# ***FALCON SERVICE BULLETIN***

## **FALCON 7X**

**No 056-R1**

**STANDARD PRACTICES  
AIRFRAME WIRING  
PROTECTION IMPROVEMENT OF VARIOUS WIRING  
ASSEMBLIES**

**Figure 16: SECTION 7X-056-6 (M980)**

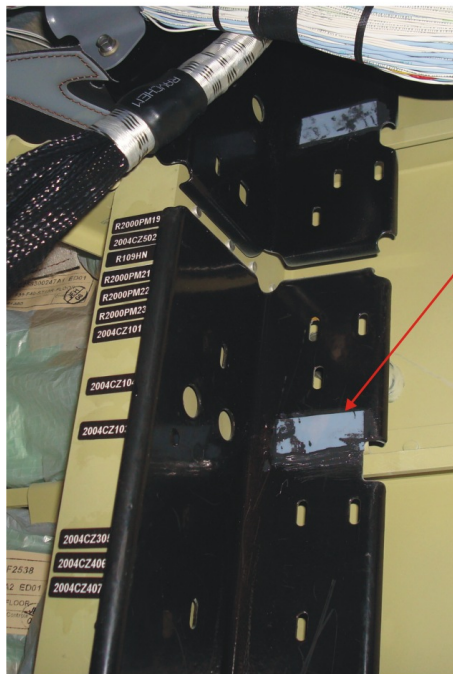
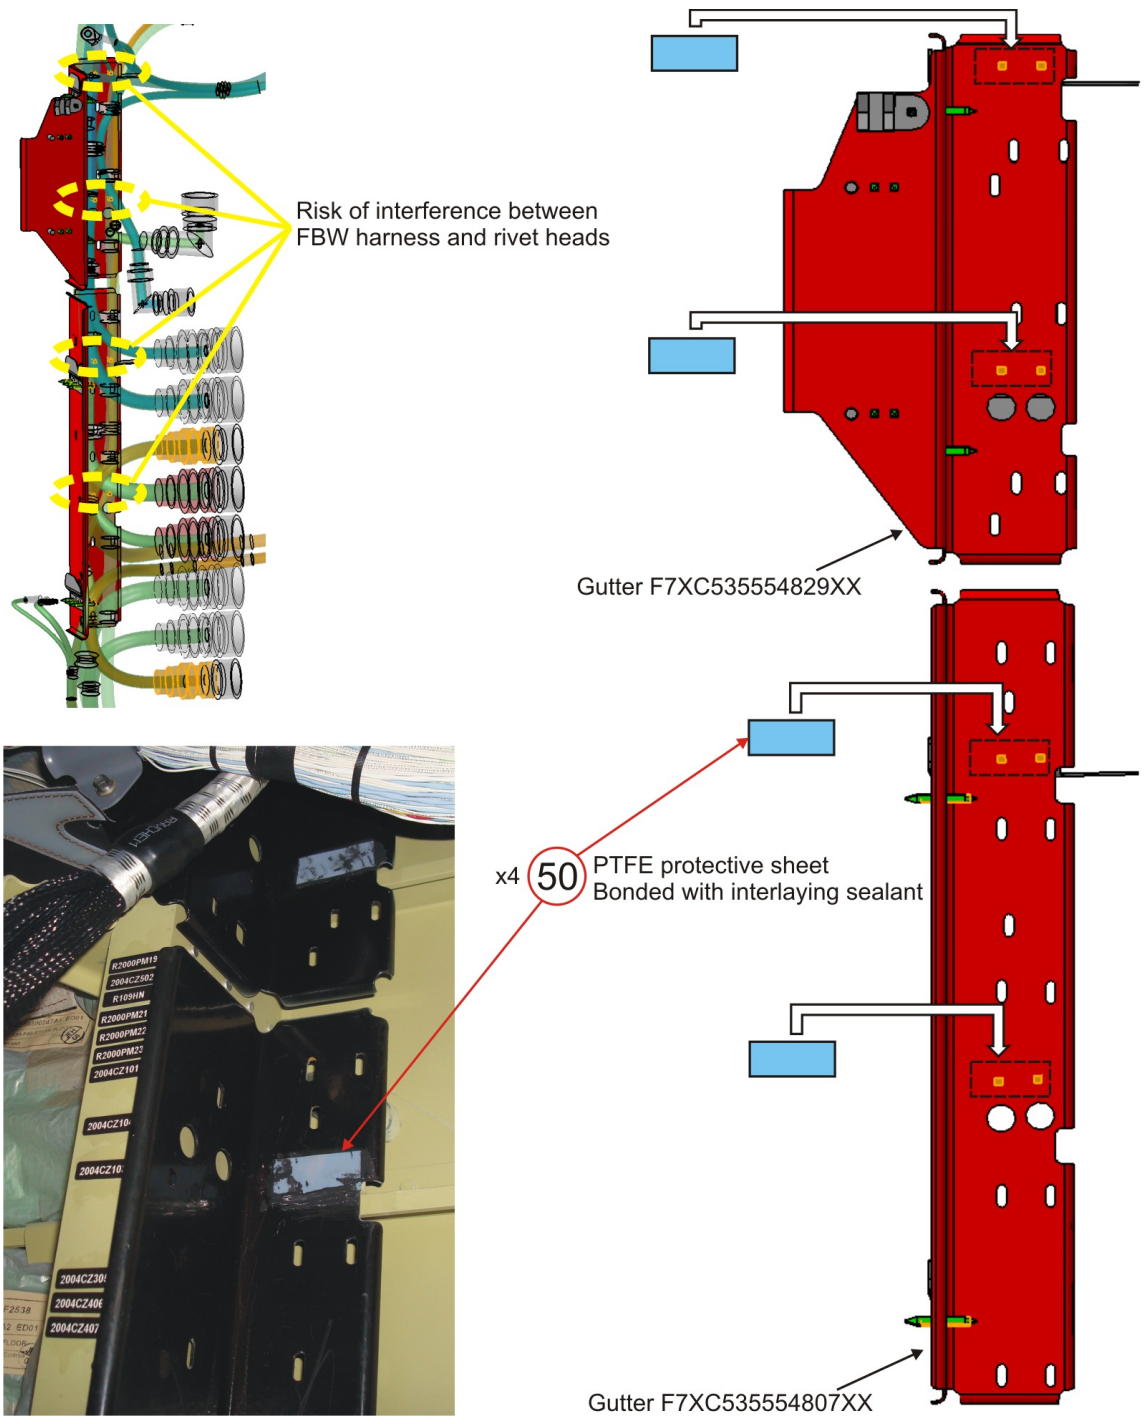
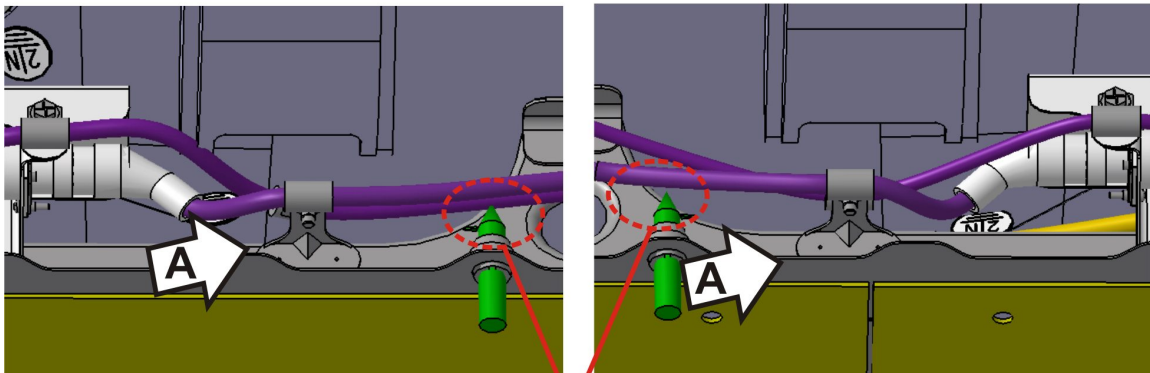
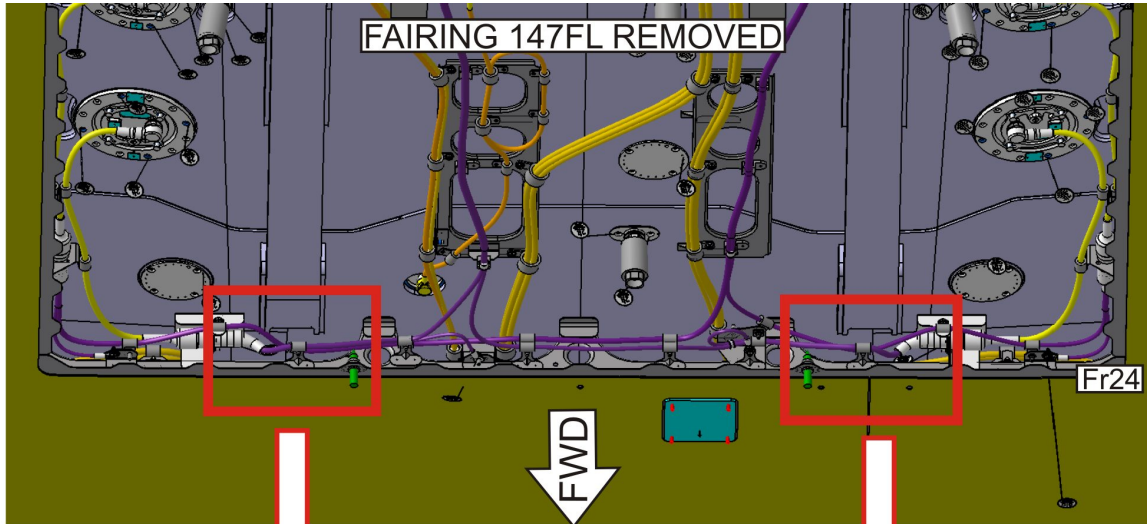
(2) On LH and RH side of the FR40, move the bundles away from the gutters and bond the new PTFE protective sheets (50-fig. 16) and (50-fig. 17) over the head rivets, using **interlaying sealant** (Refer to **TASK 20-32-00-390-801**).

**Figure 18: SECTION 7X-056-7 (M1021)**

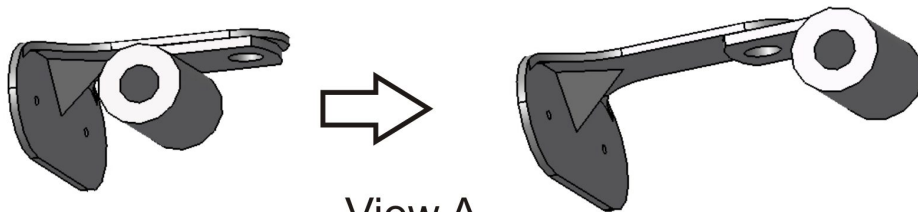
- (1) Remove the CTR fuel tank booster pump fairing (**147FL**) (Refer to **TASK 53-60-00-900-801**).
- (2) Locate the two clamps to be re-oriented. Unscrew them.
- (3) Orient the clamps in accordance with the **fig. 18** and screw them.
- (4) Install the CTR fuel tank booster pump fairing (**147FL**) (Refer to **TASK 53-60-00-900-801**).

Risk of interference between fuel booster pump harnesses and door screw

**Figure 19: SECTION 7X-056-8 (M1470)**

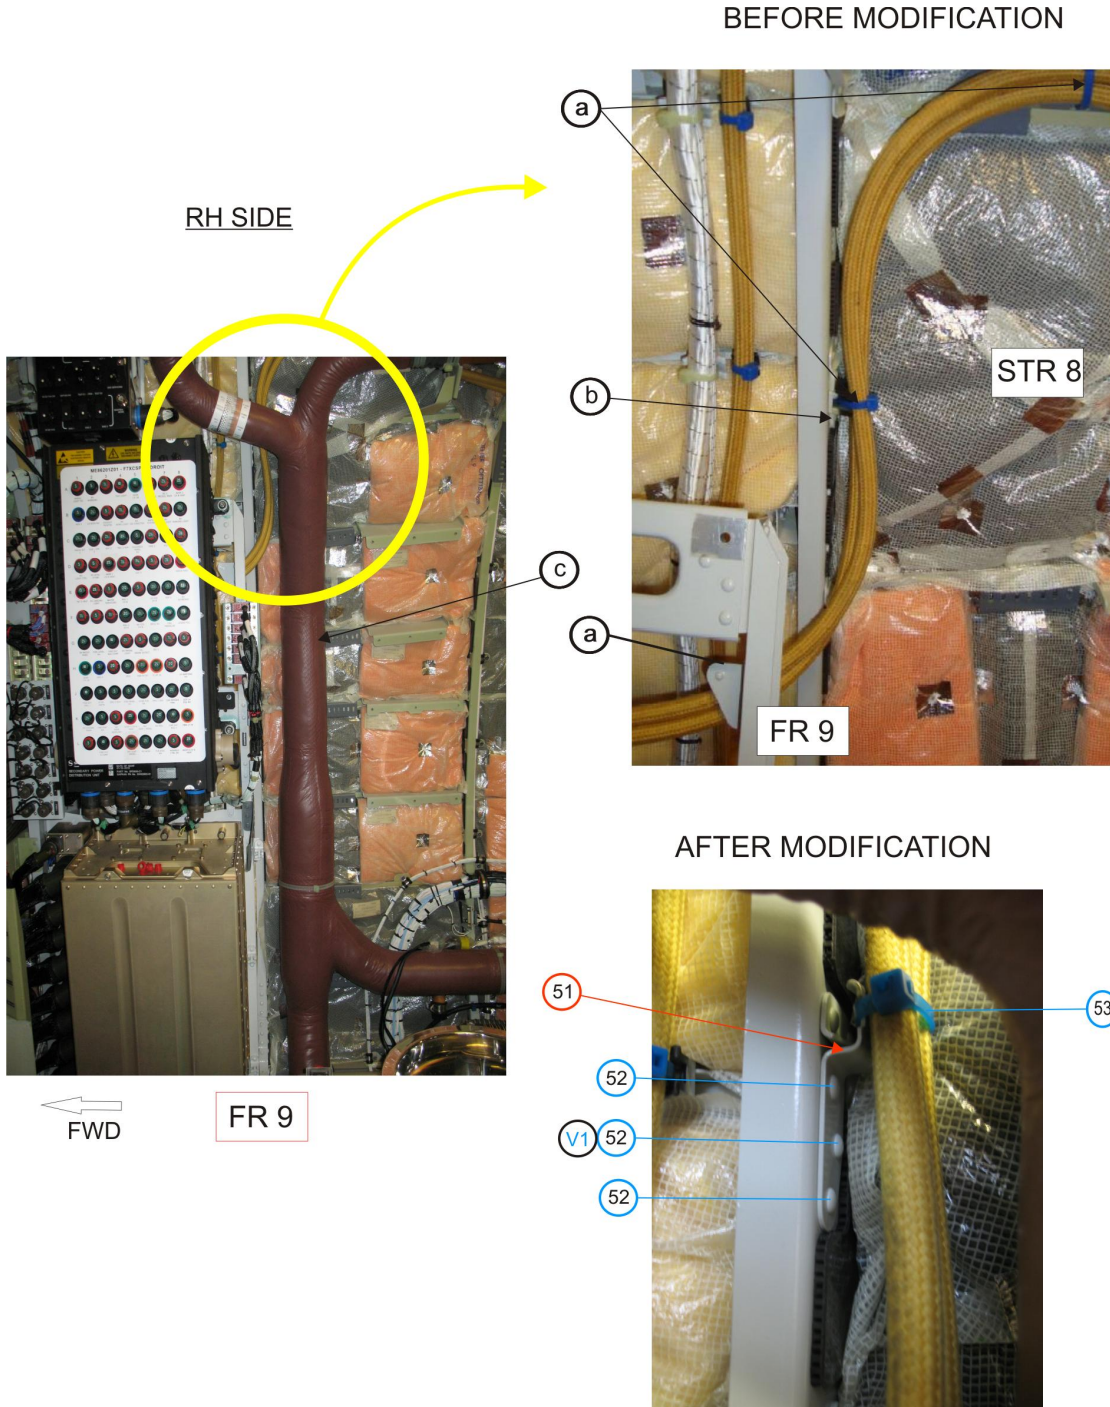
- (2) Remove cockpit lateral lining No.5 (**222XZ**) (Refer to **TASK 25-13-13-900-801**).
- (3) Remove the conditioning duct P/N F7XC213240201A1 (c-fig. 19).
- (4) Cut the cable grips (a-fig. 19).
- (5) Remove and discard the cable holder (b-fig. 19).
- (6) Position the new bracket (**51-fig. 19**) and counterdrill the third hole (V1-fig. 19) for rivet (**52-fig. 19**) (Refer to **RPI 51-40-04**).
- (7) Attach the new bracket (**51-fig. 19**) with three rivets (**52-fig. 19**) (Refer to **RPI 51-40-04**).
- (8) Route the two feeders with cable grips (**53-fig. 19**).
- (9) Install the conditioning duct (c-fig. 19).
- (10) Install cockpit lateral lining No.5 (**222XZ**).
- (11) Install the forward lavatory (Refer to SMM).
